**SUPPLEMENTARY INFORMATION****Planning Committee****15 July 2021**

WRITTEN UPDATES

19/01047/OUT - Land Northeast of Oxford Road, West of Oxford Canal & East of
Bankside, Banbury

drawing title
SITE LOCATION PLAN

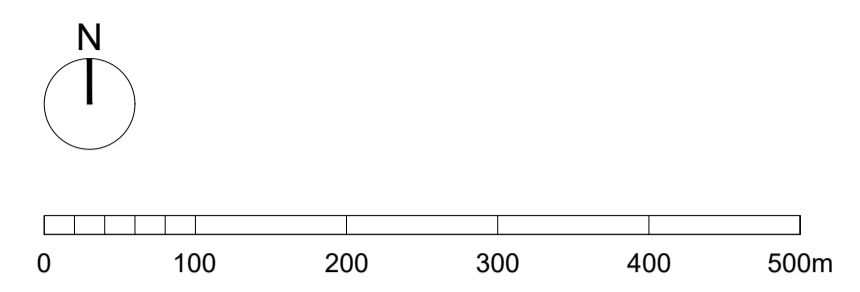
1. The **location plan** is incorrect – it shows the original application boundary, not the revised one that now includes the Football Club and Secondary School land reservations.

Agreed, see revised plans attached as an appendix to this Update.
